## A4LD UPDATE HANDBOOK INDEX

AUTOMATIC TRANSMISSION SERVICE GROUP  
9200 S. DADELAND BLVD. SUITE 720  
MIAMI, FLORIDA 33156  
(305) 670-4161

Updated  
April, 2004

Figure 70

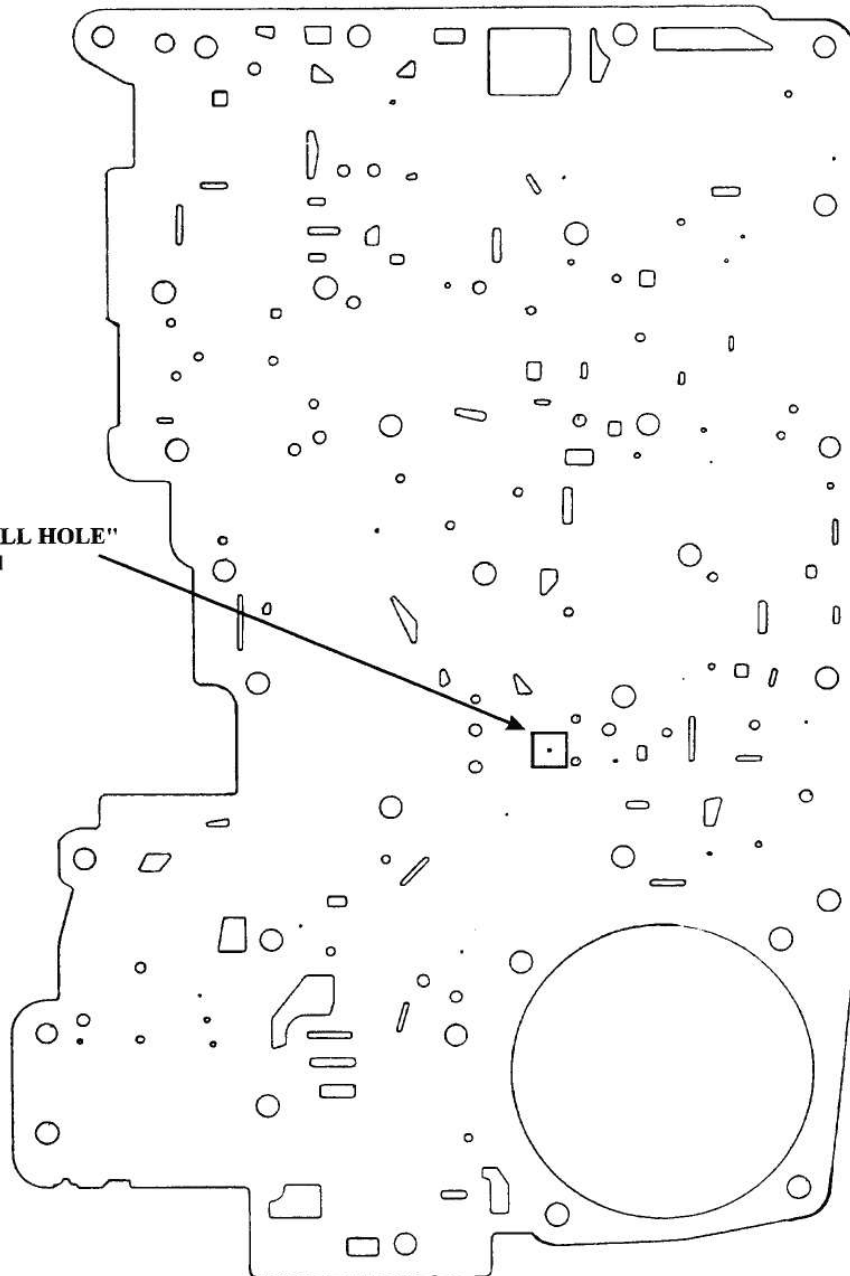
The 2nd design valve train has eliminated two springs and incorporated two spool valves into one, as shown in Figure 69. Figure 70 shows the "Small Hole" spacer plate that is required with the 2nd design line-up in bore 211.

Figure 73

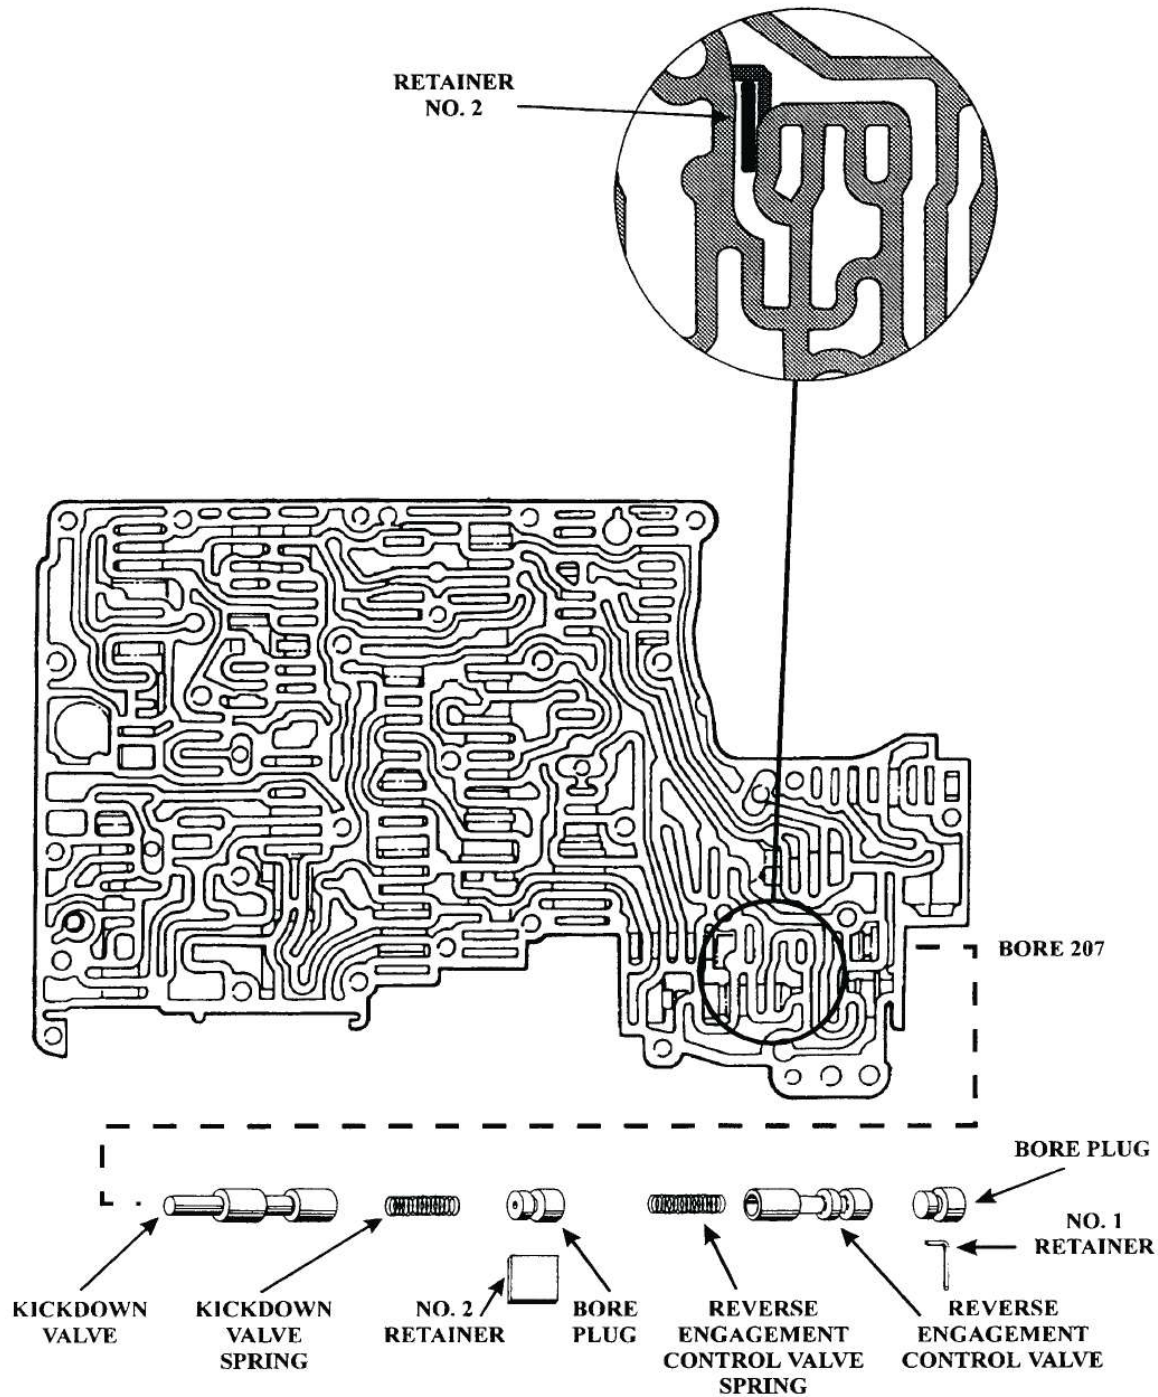
This is when the reverse engagement control valve was added to bore 207, as shown in Figure 73, and also shows the location of the No. 2 retainer in the valve body casting and the direction of the bore plugs. Figure 74 shows the "3 Hole" spacer plate that is required on valve bodies containing the reverse engagement control valve.

**Note:** Valve body castings are also different in the worm track area, when it comes to bore 207. Compare the inset in Figure 71 to the inset in Figure 73, and you will see the difference in the passages, which **will not** allow you to install reverse engagement valve into a 1st design valve body casting.

Figure 76

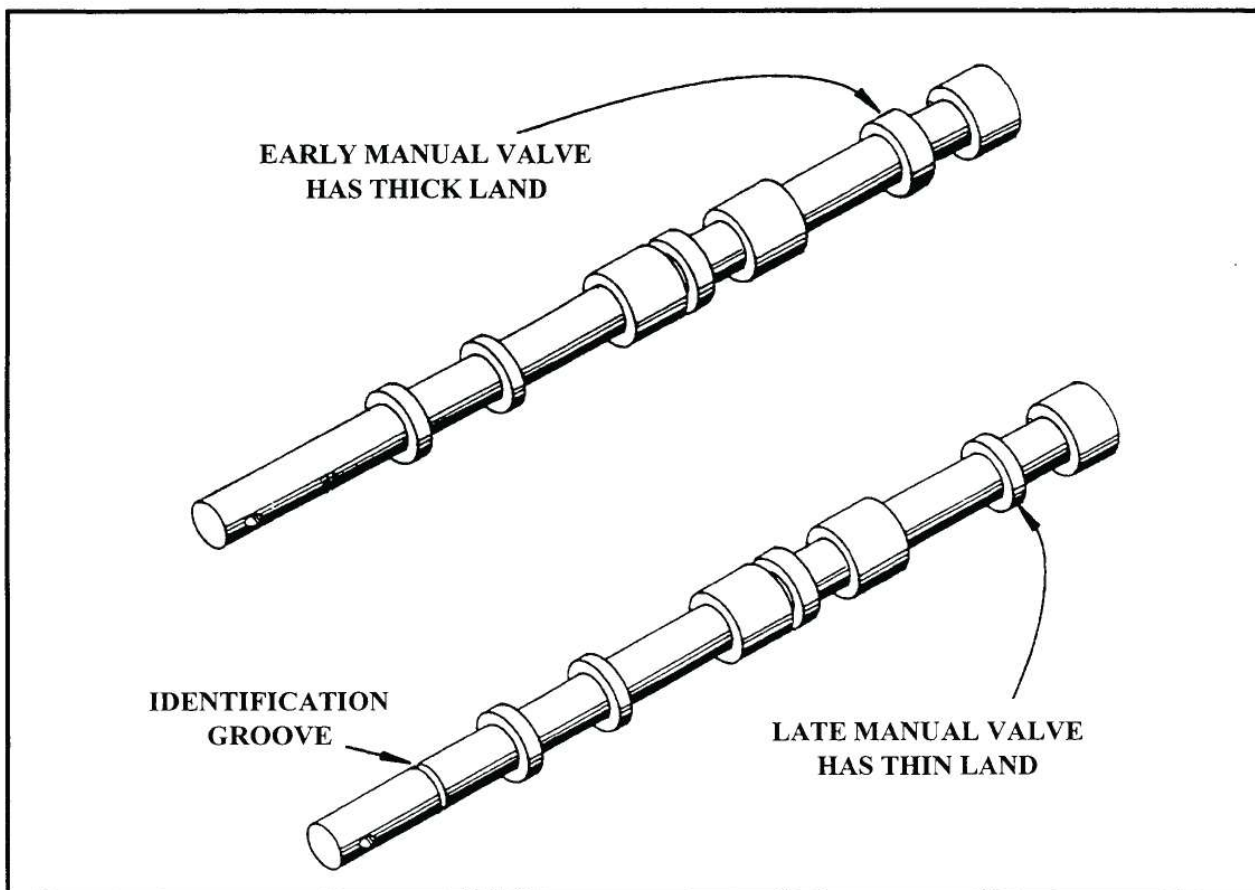
**MANUAL VALVE** - The 2nd design manual valve has a thinner land on it as shown in Figure 76, and is identified by a groove just behind the manual valve link hole.

Manual Valve (2nd Design)..... E8TZ-7C389-A
